Harper Canyon (Encina Hills) Subdivision Project
Final Supplemental
Environmental Impact Report
SCH# 2003071157
PLN 000696

December 2024

County of Monterey
2441 Schilling Place
Salinas, California 93901

Denise Duffy & Associates, Inc.
947 Cass Street, Suite 5
Monterey, California 93940

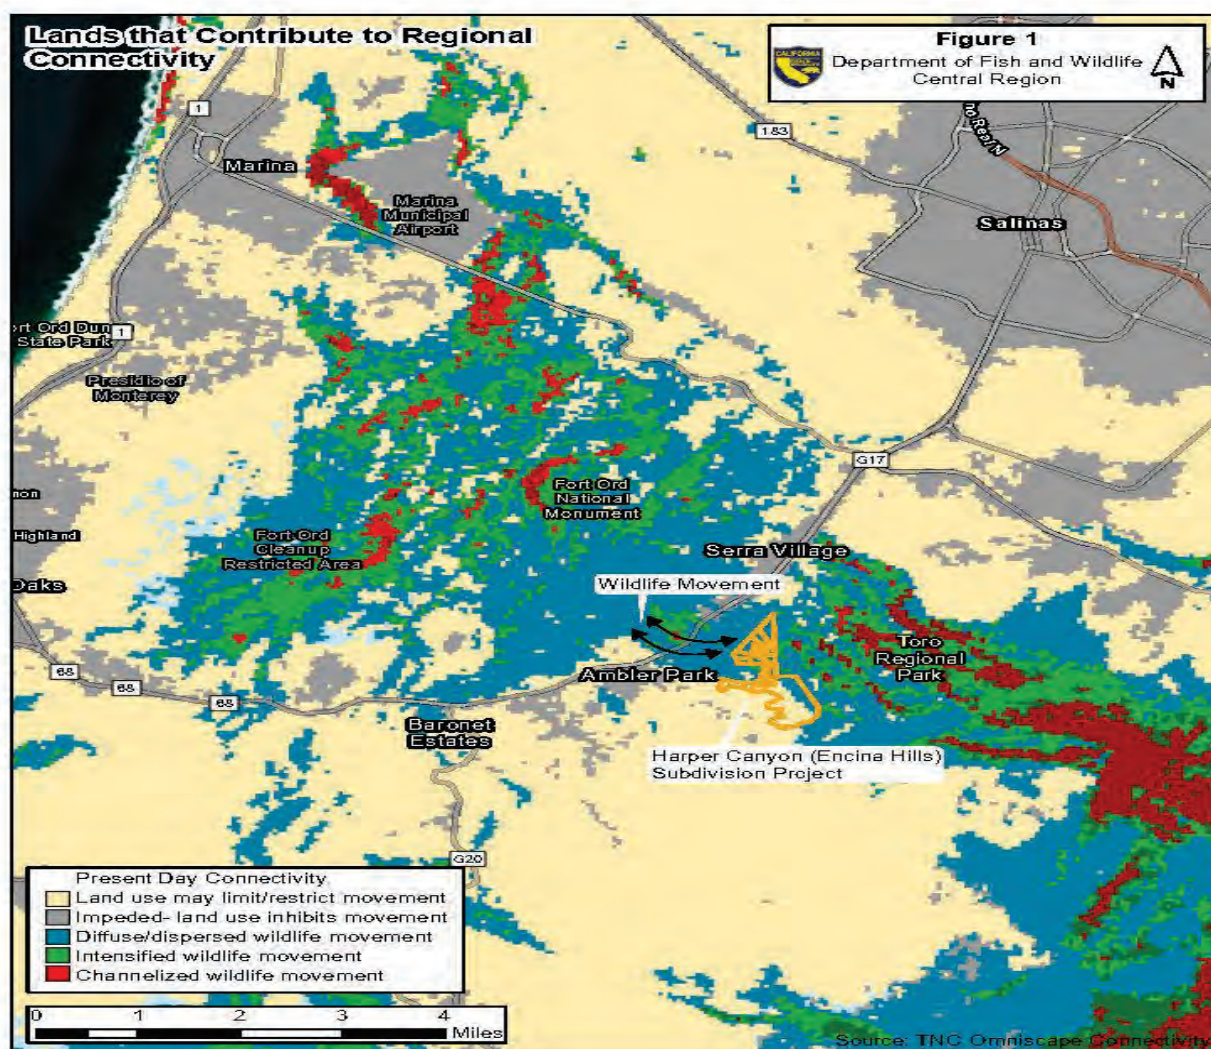
The Project's 17-lot residential subdivision would almost entirely block a primary wildlife corridor between Fort Ord and Toro Park and further isolate Fort Ord and the wildlife species that inhabit the monument (Attachment 1, Figure 1). Attachment 1, Figures 1 and 2, utilize The Nature Conservancy (TNC) Omniscape Connectivity Web Map (TNC 2024) dataset to model wildlife movement within and surrounding the Project site. As Attachment 1, Figures 1 and 2, depict, the majority of the residential subdivision is directly within the sole migratory pathway between Fort Ord and Toro Park. While the SDEIR recognizes the potential impacts to wildlife connectivity associated with the siting of the Project site, and specifically provides mitigation measures to protect a portion of the El Toro Creek corridor, CDFW is concerned that without the protection of the surrounding movement pathways identified in Attachment 1, Figures 1 and 2, the Project would not adequately mitigate for the impacts to wildlife movement.

The comment acknowledges that the mitigation measures identified in the SDEIR protect a portion of the El Toro Creek corridor. However, the comment expresses concern that without protection of the surrounding movement pathways (identified in Figures 1 and 2 of the attachment to Letter E), that project would not adequately mitigate for the impacts to wildlife movement. As stated in this response, the proposed project would provide additional

protection of the surrounding movement pathways by maintaining a 180-acre open space parcel, donating 154 acres of that parcel to expand Toro County Park. Portions of this parcel fall within the diffused/dispersed movement areas, which are those categorized by The Nature Conservancy as areas with high flow (e.g., areas of open space with limited human modification). It should be noted that the other surrounding movement pathways identified as diffused/dispersed movement areas in Figures 1 and 2 include the Fort Ord National Monument, Toro County Park, and Marks Ranch, which are currently protected as open space. Lastly, as a mitigation requirement, corridors through the project site will be identified in the final map where no development shall occur.
